NEW & IMPROVED EMERGENCY VENT KITS FOR TRANSCUBES

Western Global has improved their emergency vent kits for the TransCube fuel tanks.

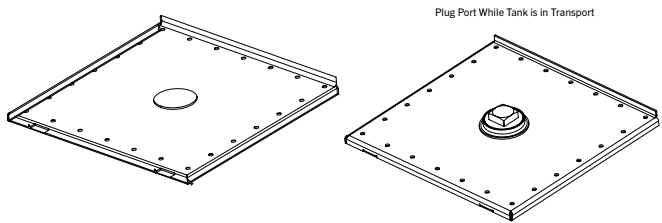
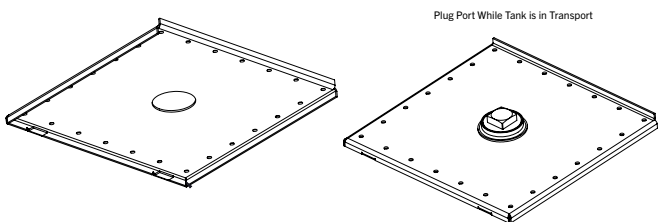
Previously, customers had to remove the manway cover and have a bung welded into it before using the kit. However, with the new kits, customers will receive a manway cover with the bung already welded at the time of delivery. The manway cover also includes an anti-theft grill at the bottom for security.

Additionally, the 48" vent stack is no longer necessary, and customers only need to install the male threaded vent in the bung on the manway cover to prepare the tank. The exception is in Canada, where a tank whistle must still be installed in the cabinet.

NOTE: In accordance with NFPA30 and extended vent pipe will be required for the 40TCG and 50TCG when storing gasoline adjacent to a building or public way. WG would suggest to relocate tank if possible or an extension piece can be added.
